SERVICE INFORMATION

STANDARD AND TRIUMPH VEHICLES (NOT FOR PUBLICATION)

No. SPORTS/2/S EXHAUST PIPE VIBRATION Date MAY 1956

1 ILLUSTRATION.

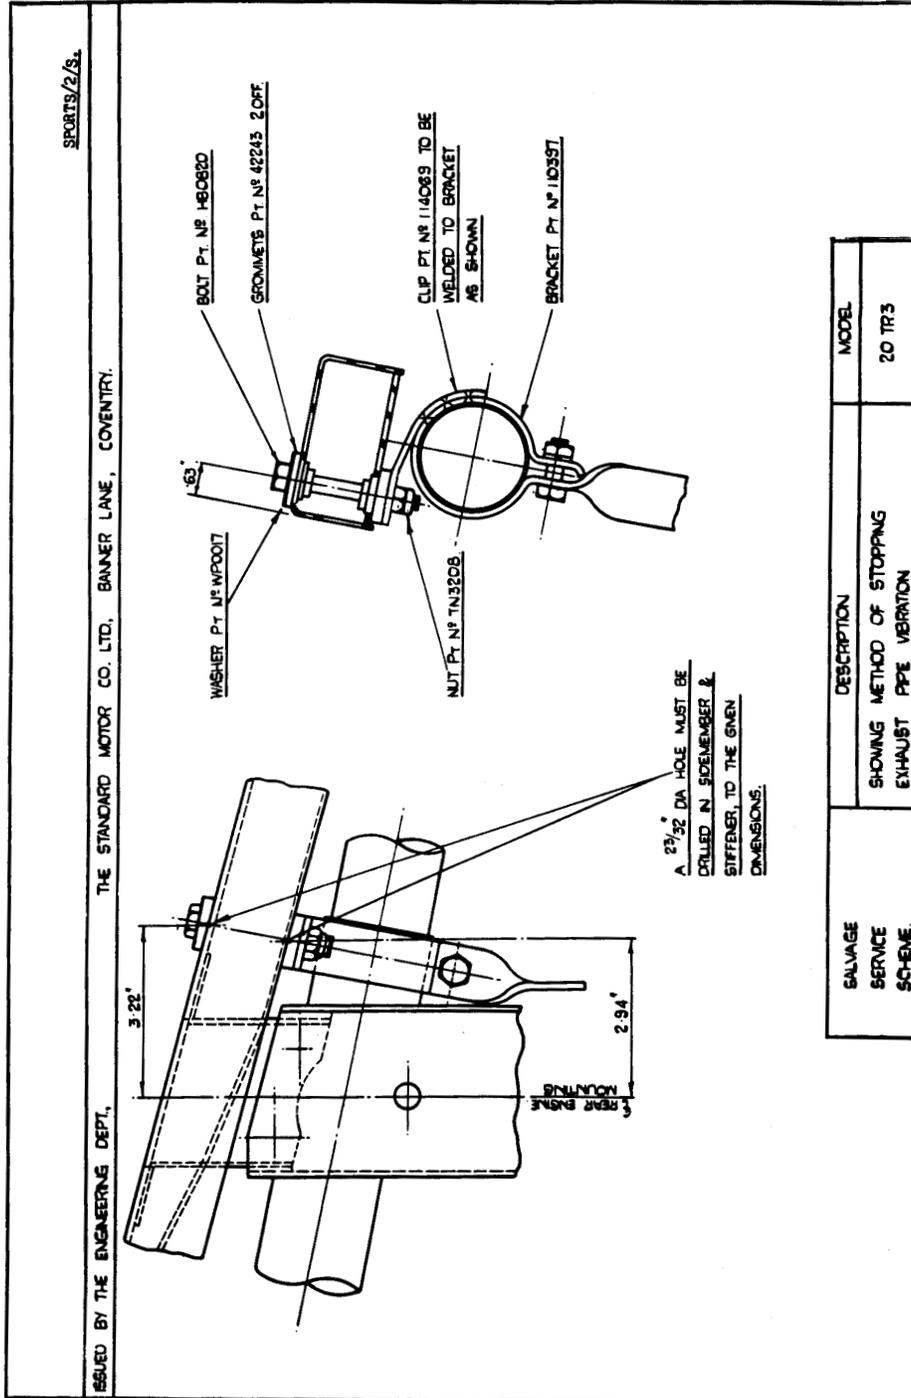
If an exhaust pipe vibration, which is not infrequently thought to be an engine vibration, is experienced at 2000-2500 r.p.m. the forward exhaust pipe mounting can be modified as shown in the illustration. The following parts are affected by this change:

1. Exhaust pipe support bracket, Part No. 110397, has been replaced by support bracket assembly, Part No. 114074.

It will be seen from the parts affected that the flexible mounting strip supporting the original bracket, Part.No. 110397, in a vertical plane has been deleted.

The original mounting used on the L.H. section of the cruciform, which supports the front pipe bracket, remains unchanged. The new mounting, which is an identical assembly to the latter, is used to support the R.H.S.of the bracket and is attached to the R.H. section of the cruciform.
